From: Ramon Samanes <ramon@uitownplan.com.au>
Sent: Thursday, 12 December 2024 12:10 PM
To: Planning & Environment Team; Mail Cook
Subject: DA/4755 - Response to Information Request - Material Change of Use - Dual Occupancy (Landslide Hazard Overlay) - 20 Webber Esplanade, Cooktown
Attachments: Geotech report Dec 2024[1].pdf; 20 Webber Esp. V1. TownP Review 9.12.24 (2) [2].pdf

**SUBJECT: Response to Information Request
Material Change of Use – Dual Occupancy
Located at – 20 Webber Esplanade, Cooktown
Formally Described as – Lot 14 on C17946**

We refer to Council's request for further information received on the 27 May 2024. Council in their request deemed it necessary to request further additional information to allow them to complete the assessment of the application.

Figure 1: LiDAR Surface Elevation and Contours (0.5m contour spacing)

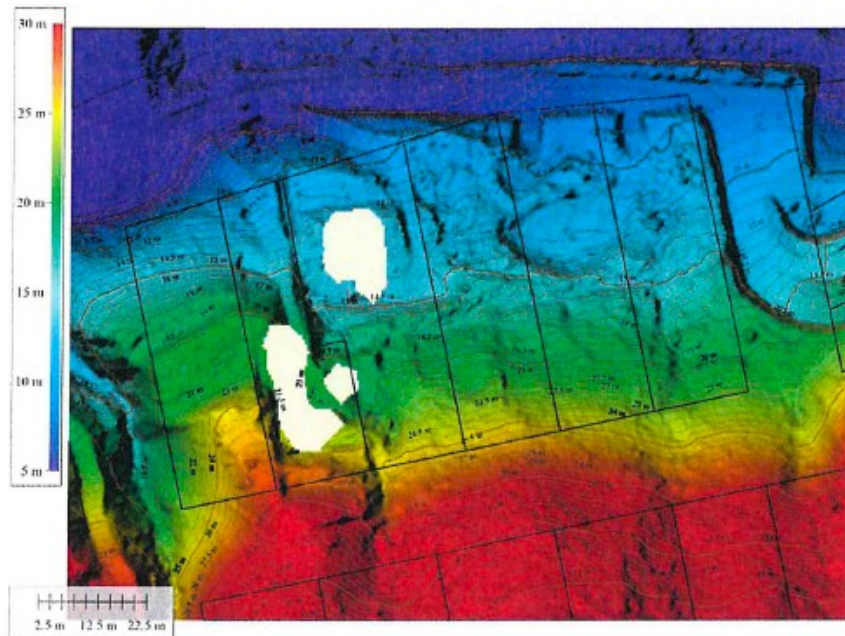
The LiDAR Surface Elevation and Contours indicates that stormwater runoff falls south to north, and is discharged to the road frontage. Noting the steep nature of the site and batter/retaining wall along the property frontage, concerns are raised regarding potential impact to stormwater runoff if flows are concentrated as a result of the proposed development.

2. The Applicant is requested to demonstrate provision is made for the proposed retaining walls to include adequate drainage behind the top of the wall to ensure surface stormwater flows do not flow over the top of the wall but are contained in a designed system to pass the wall.

The plans have been amended to include the provision of a retaining wall to enhance the safety and prevent vehicles from reversing off the driveway edge, also to stop any stormwater along that section of the driveway. In terms of the remainder of the proposed stormwater controls, as noted on the plans all the roof water will be captured and piped to legal point of discharge within the road reserve. The proposed driveway will be designed to fall to the west along the existing driveway stormwater and not over the top of the wall. We hope that satisfies councils concerns regarding stormwater in item 2.

Project	COOKTOWN MODULAR CONCEPT
Client	MORGAN COLEMAN
Title	SWEPT PATH ANALYSIS
Number	A10.02
Scale	1 : 100@A3
Revision	B
Description	
Status	PRELIMINARY
Drawn	HANC
Date	9/12/24

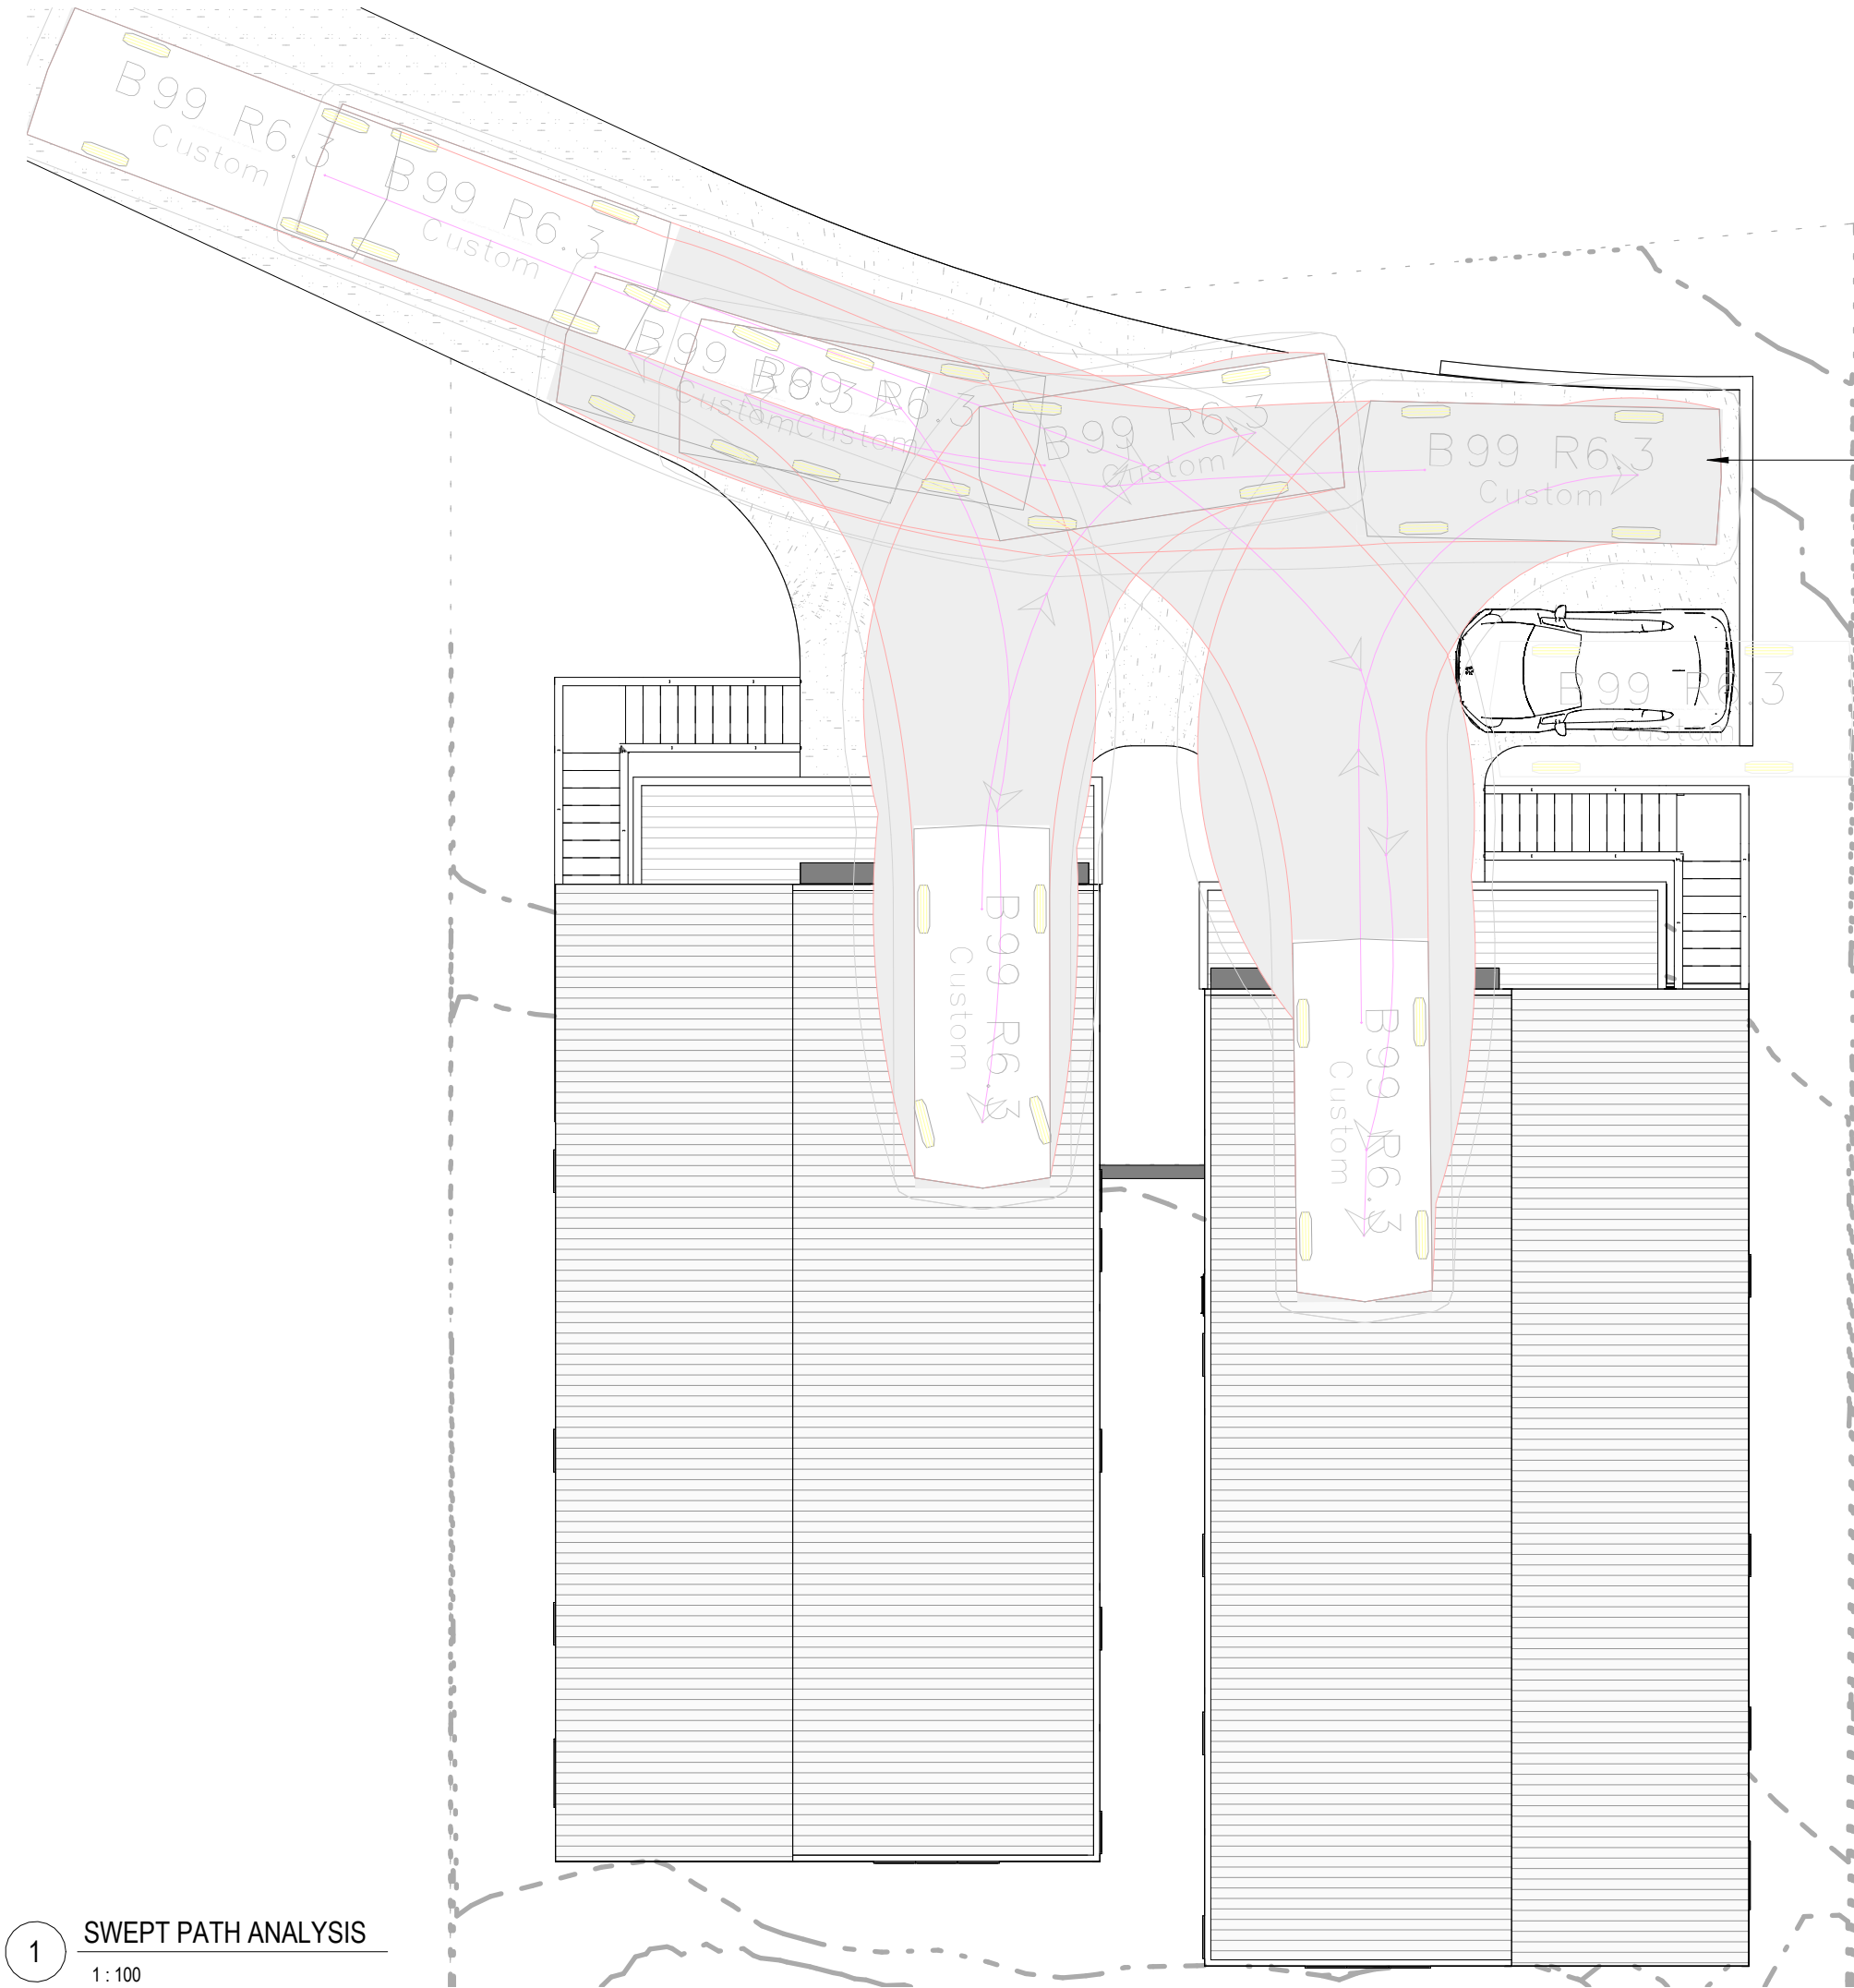
Concerns are raised that the proposal plans have not addressed safety concerns of vehicles reversing near the steep drop off hazard represented by the existing batter/retaining wall within the site frontage. The Applicant must provide amended plans of the site access and car parking area, prepared by a Registered Professional Engineering Queensland (RPEQ), which enable definition of safety concerns and demonstrate provision in accordance with the AS 2890.1:2004 Parking facilities – Off-street car parking. The plans must address but not be limited to the following:

The turnaround and swept paths have been shown on page 6 of the plans which addresses item 5.
